177/2011/P - 54 Thorpes Lane LAKES ENTRANCE

Lot 2 on PS 712500K

Multiple lot subdivision, roadworks, removal of an easement and removal native vegetation

Responsible Authority Conditions

STAGING PLAN

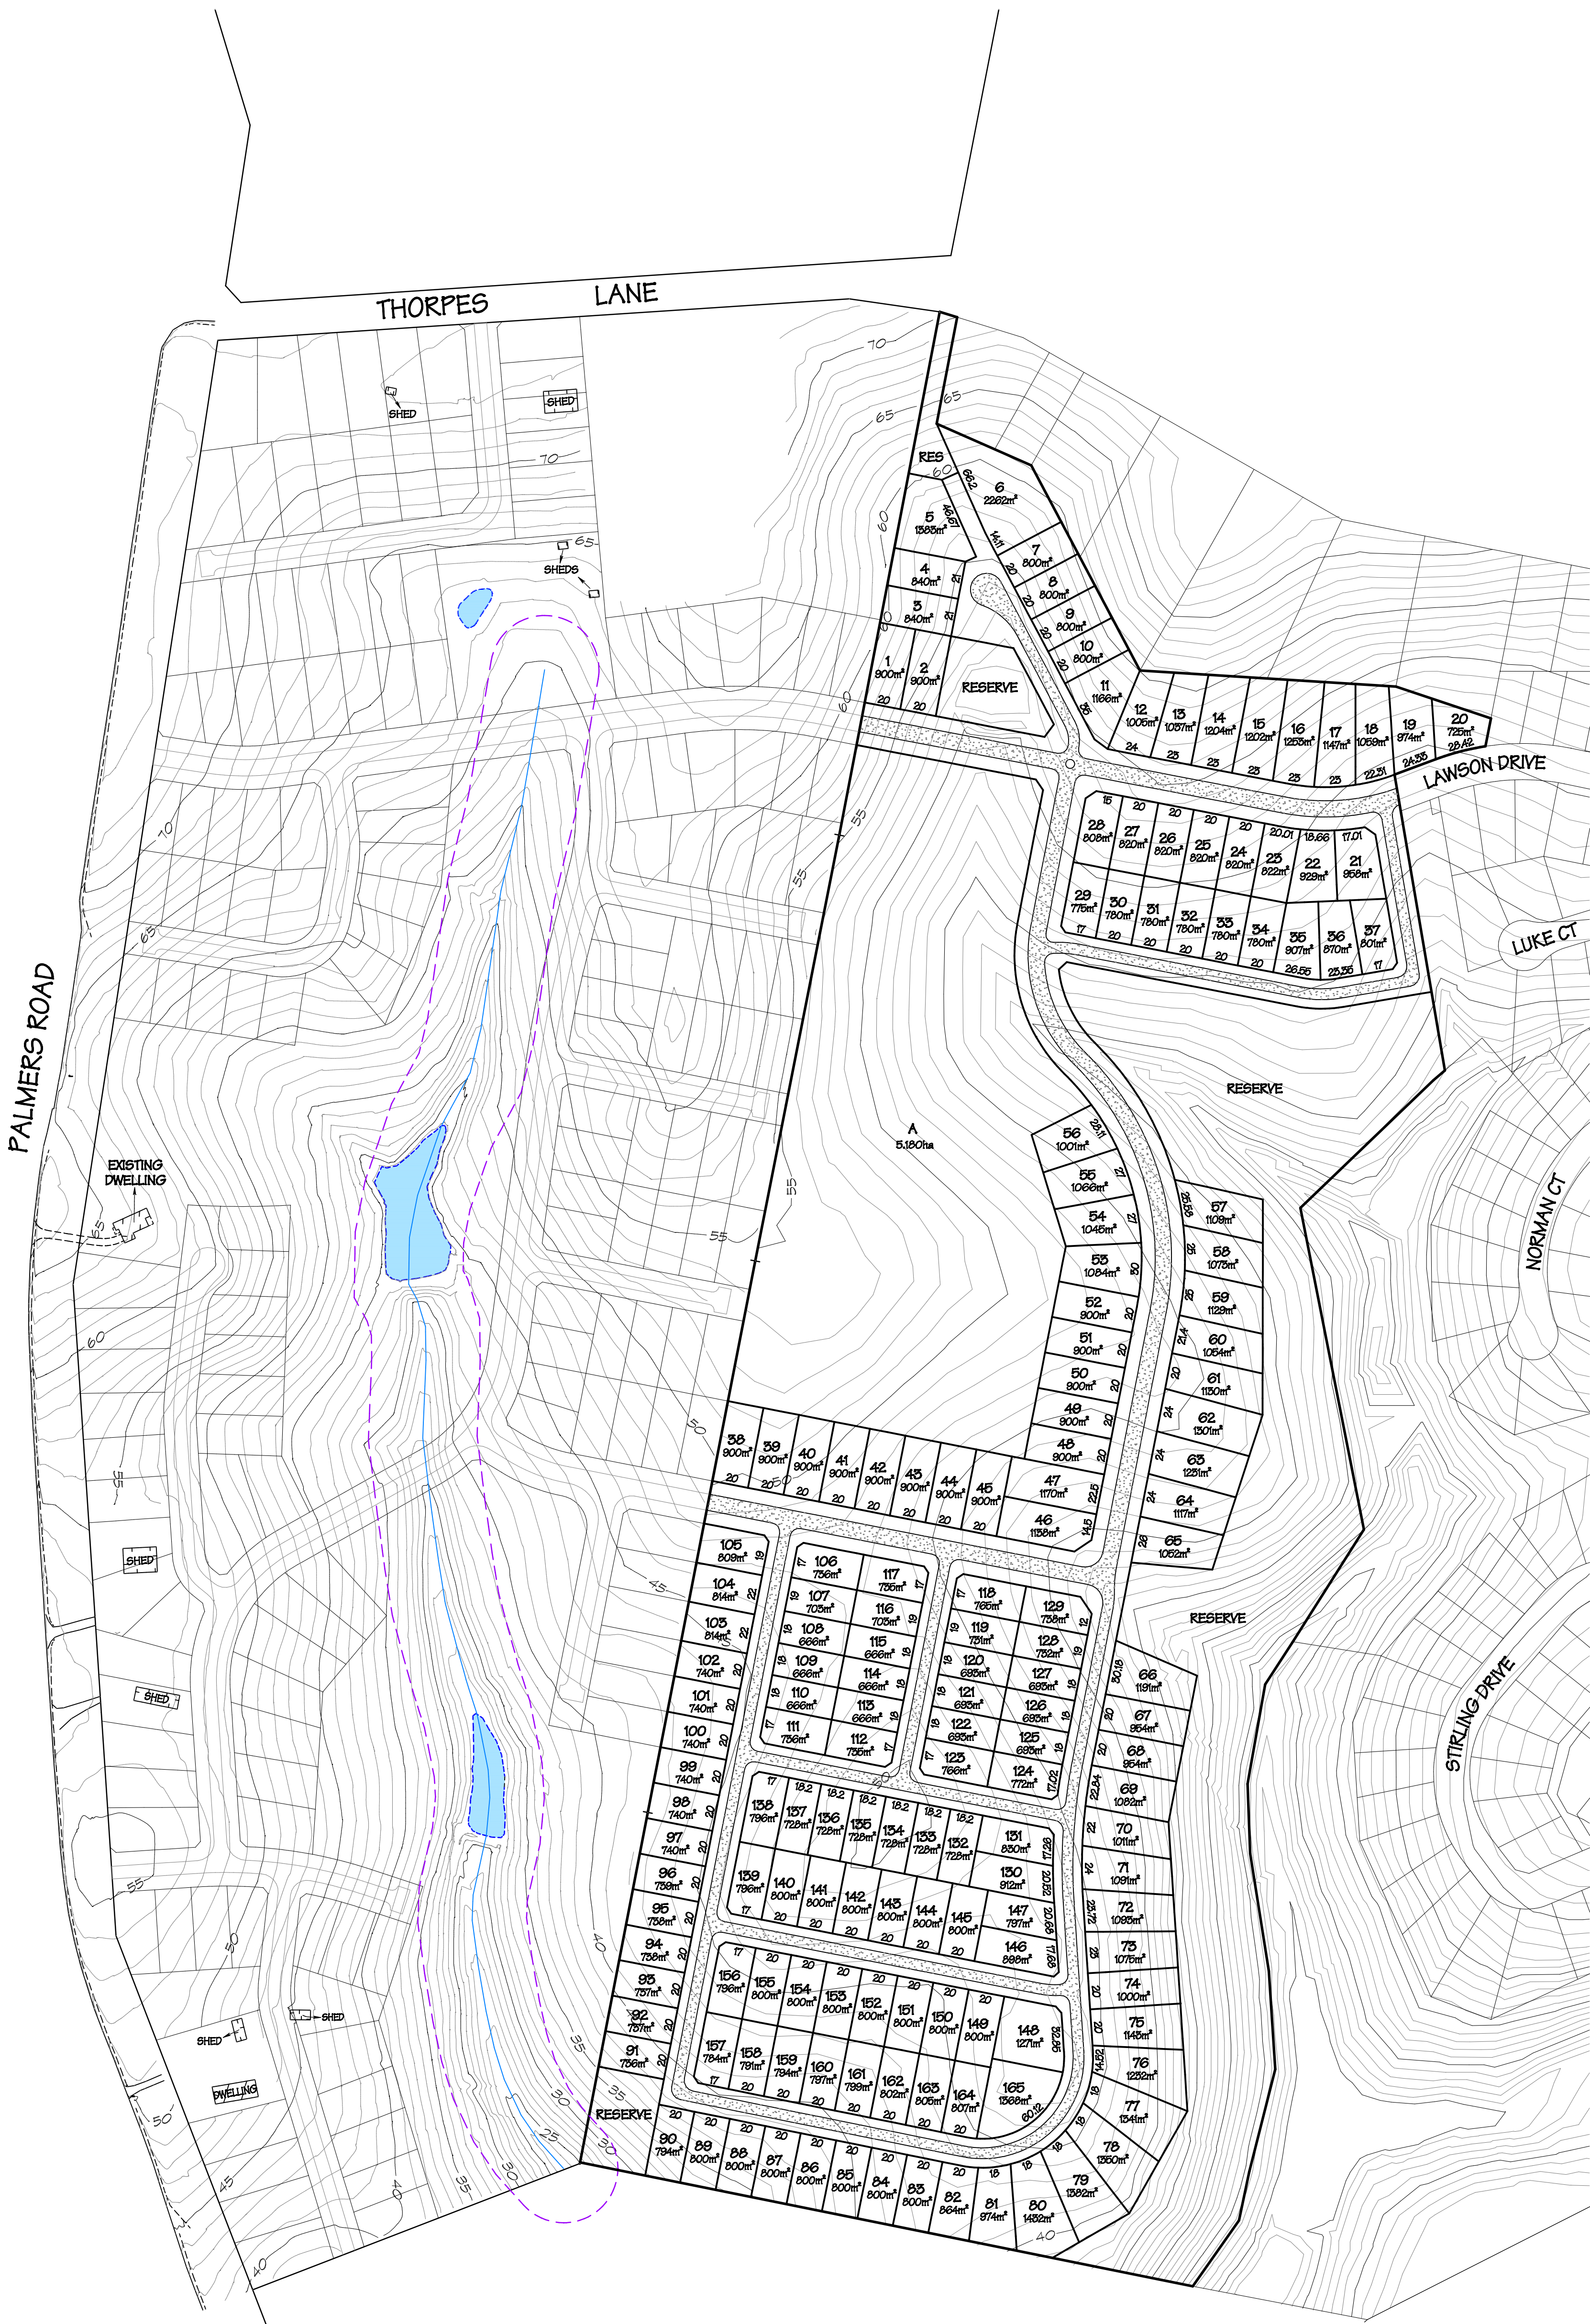
- c) Staging Plan v.1 (Crowther & Sadler Pty Ltd, 11 July 2017) modified to show:
 - Lots 1-5, 38, 39, 91-105 inclusive, a 40 metre width on the western portion of Lot A and the public open space in stage 7 to be included in the final stage of development.

Figure 7: Indicative Access

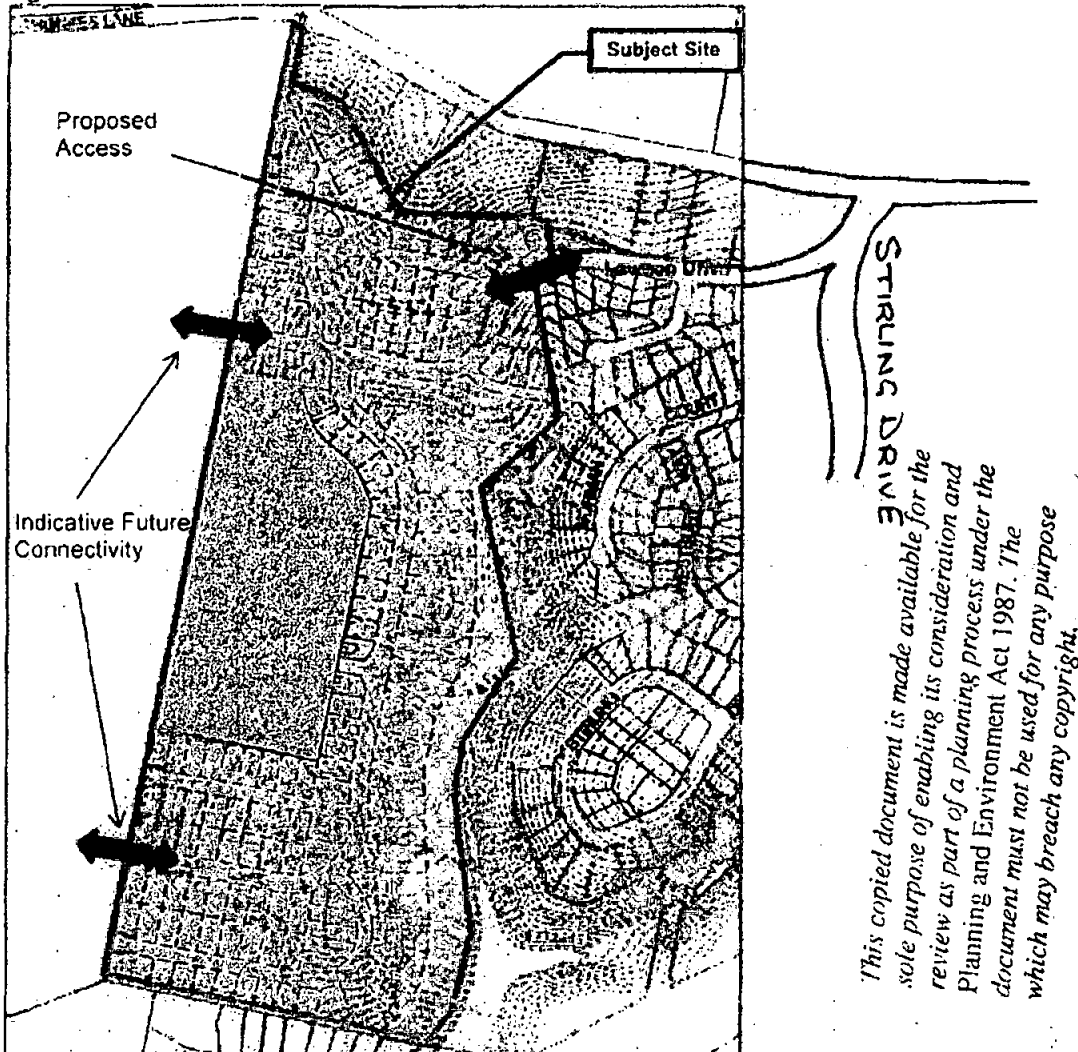
On viewing the application documents, and specifically the Road Network and Traffic Management Plan (see attached) it appears that access to this latest subdivision area during construction and into the future is limited to Lawson Drive.

The report states that "given it is not practical to provide access onto Thorpes Lane without land acquisition" and "direct road access to Palmers Road will require acquisition of third party land and construction of significant infrastructure **not required for the proposed subdivision**".

This is plainly, unprofessional and cheap planning and subdivision
Adequate access to Palmers Road is required for the proposed subdivision

Previous planning proposals for this area showed several access roads to Palmers Road. Our comments on that proposal at the time were not only were these access points mandatory, but should be established before subdivision construction commenced.

Access to Palmers Road is a vital issue for the viability and sensible planning of this proposed large lot subdivision.
